CONSTRUCTION PLANS
FOR
CREEKSIDE AT LORSON RANCH FILING NO. 2
STREET AND STORM SEWER CONSTRUCTION PLANS

SF 23-XX

V1_Construction Drawings (Plans_Profiles).pdf Markup Summary

**CREEKSIDE SOUTH AT LORSON
RANCH FIL. 2 - HORIZONTAL CONTROL
PLAN & SIGNING PLAN**

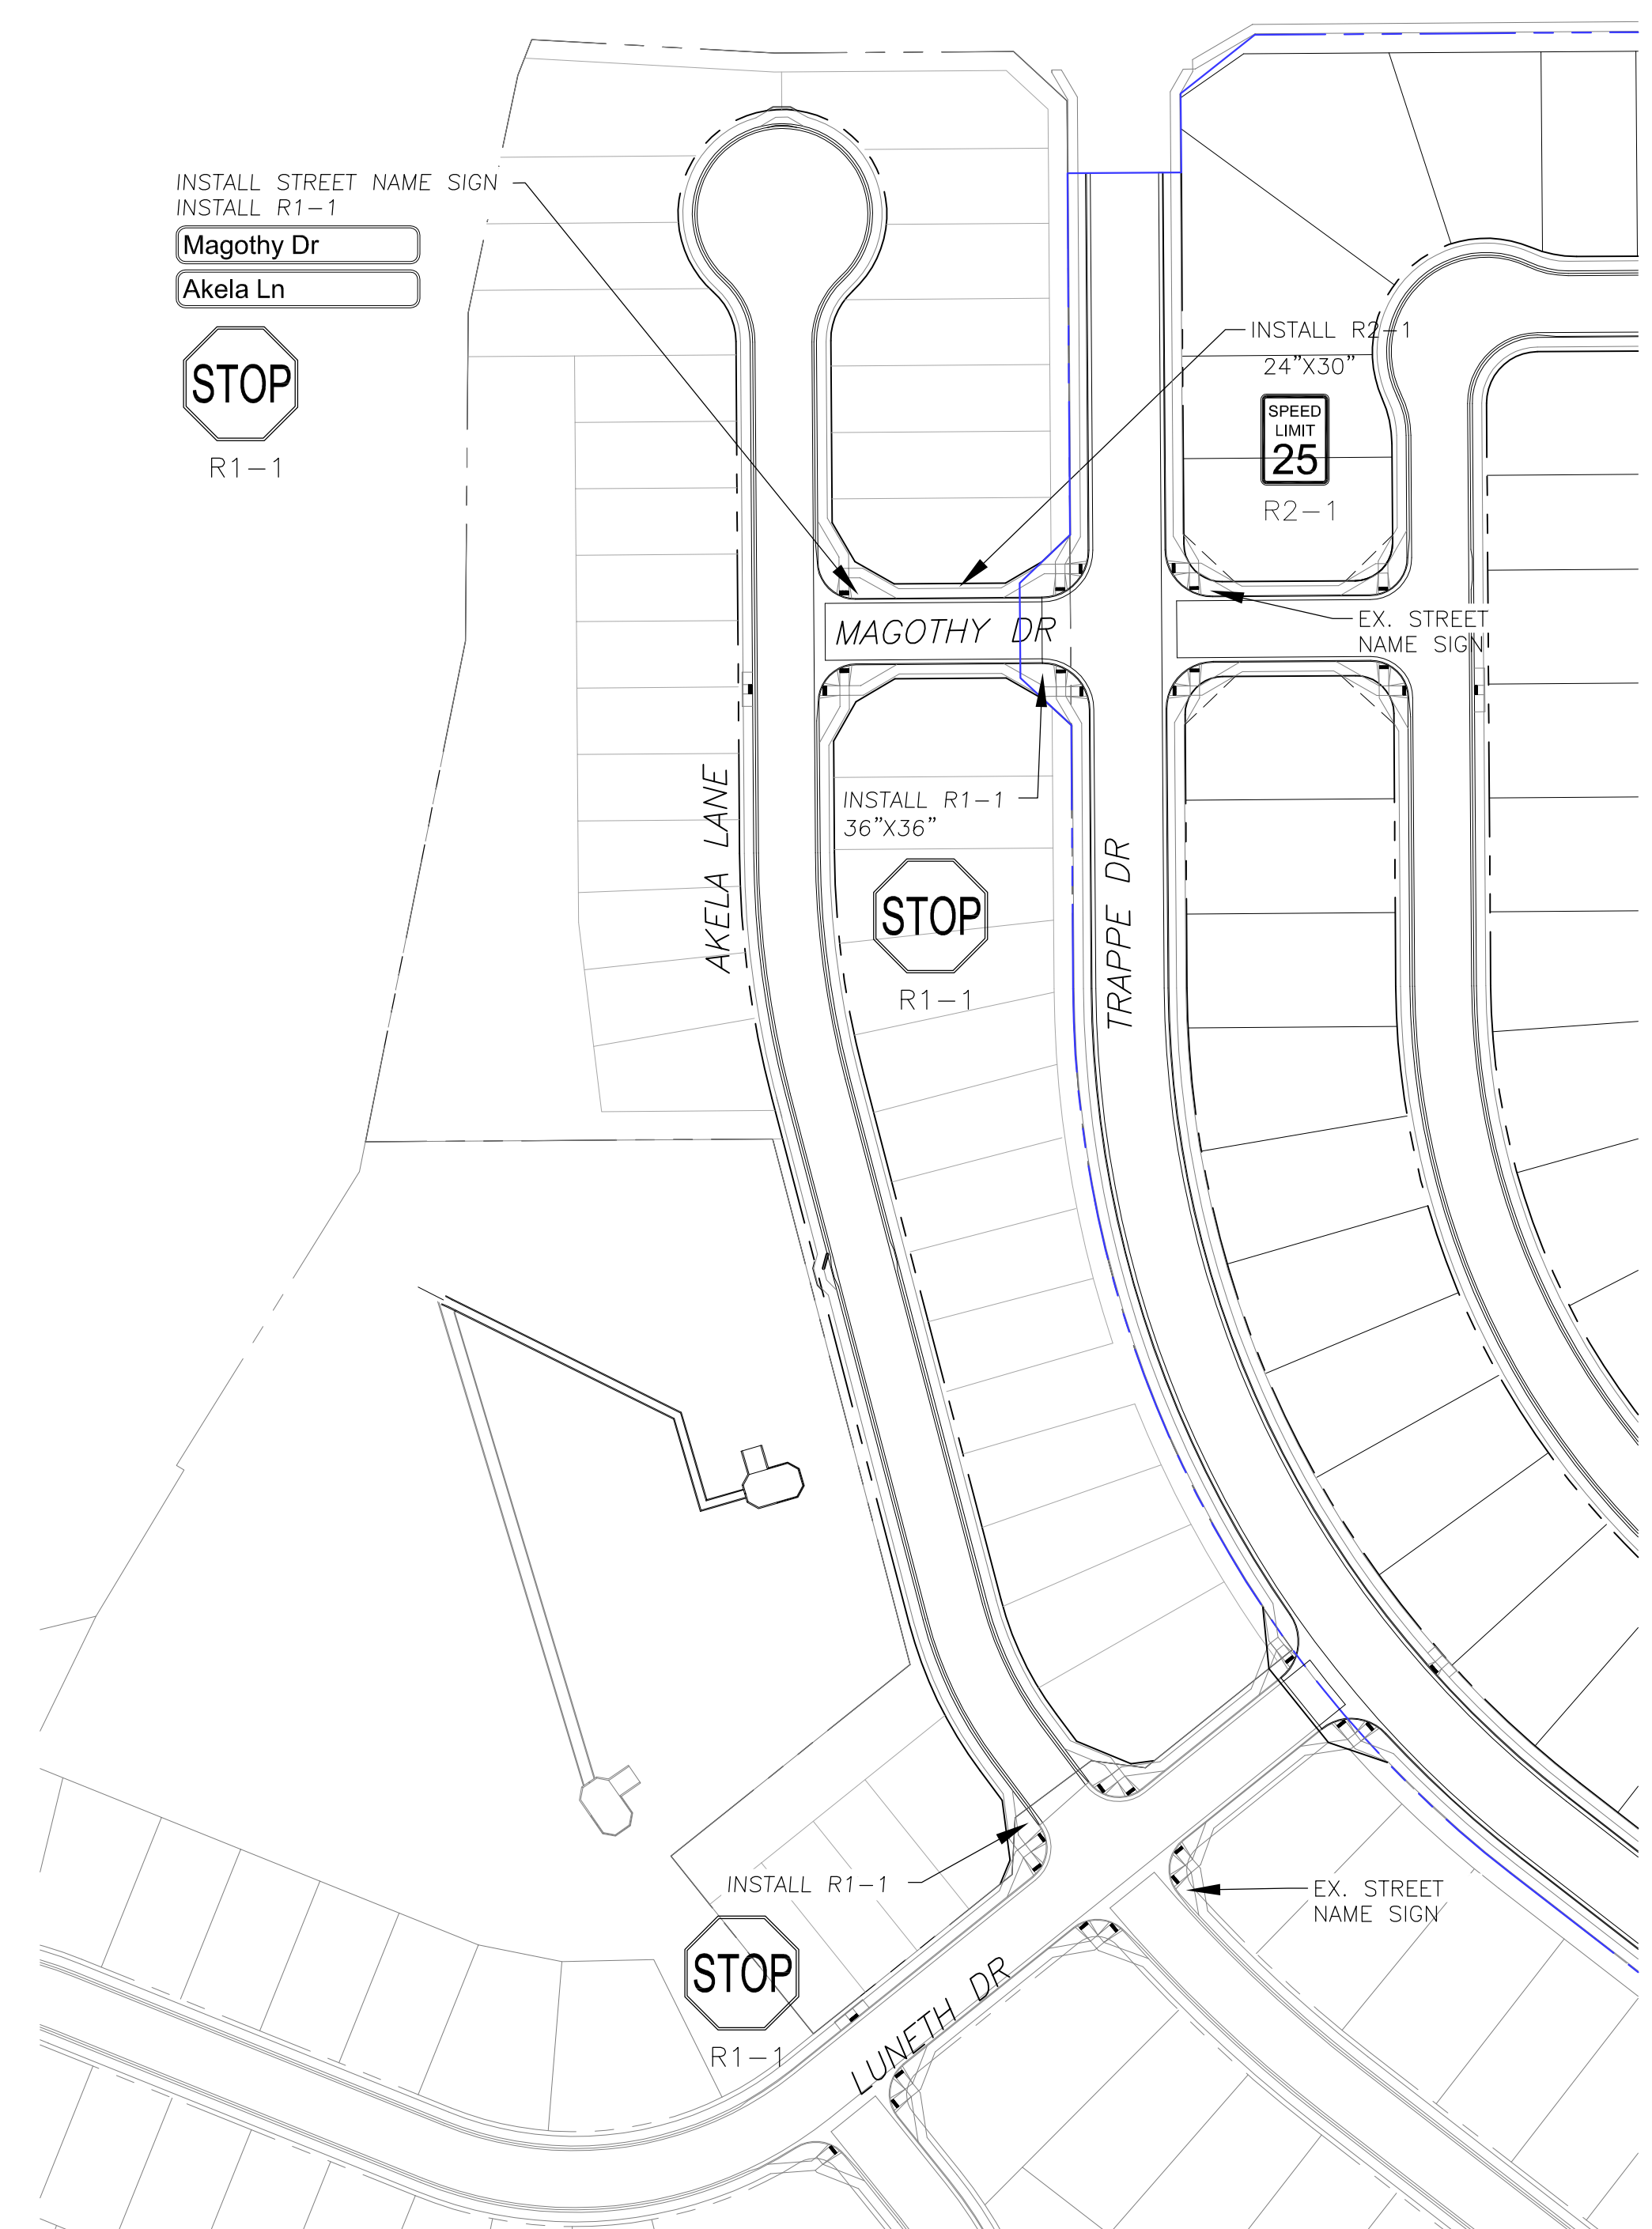
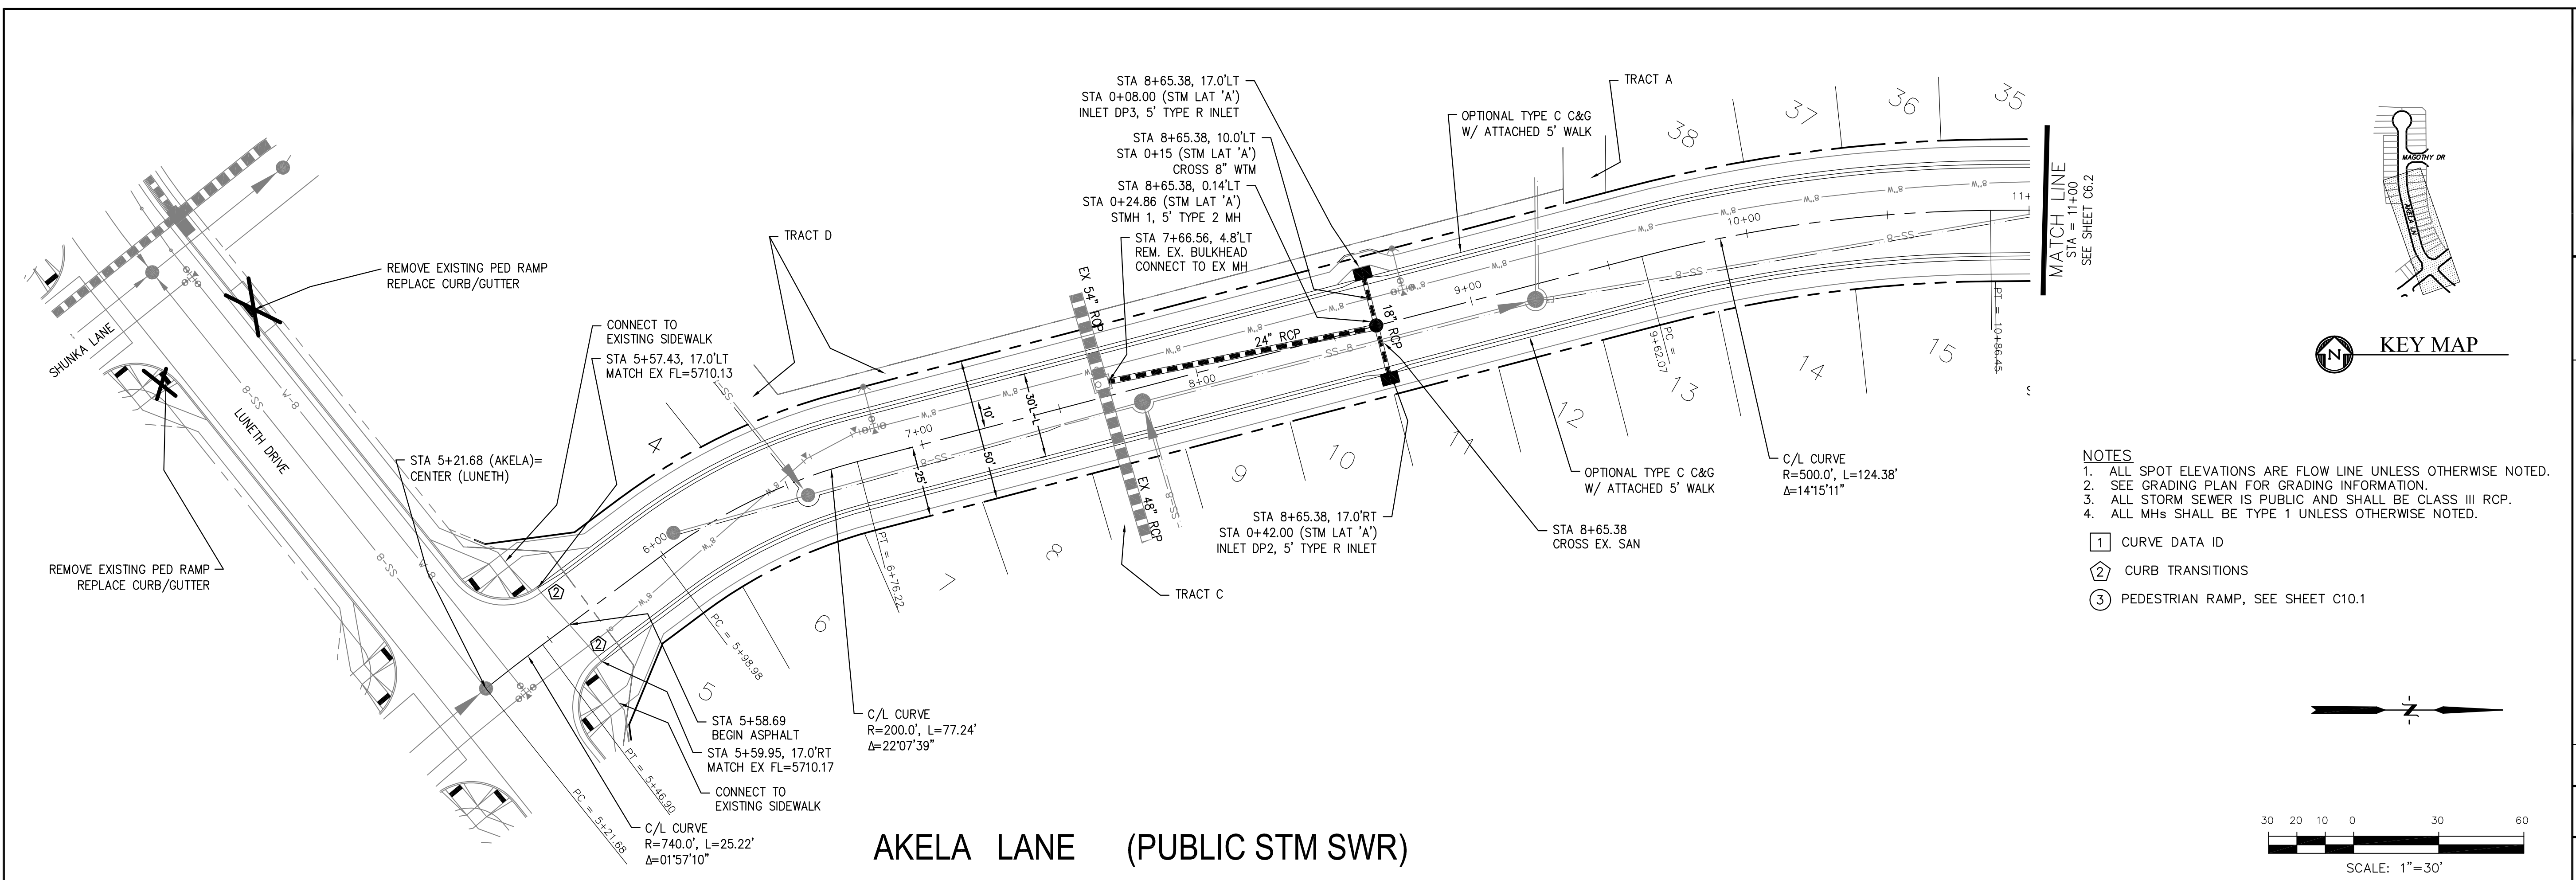
Include length and bearing for centerline
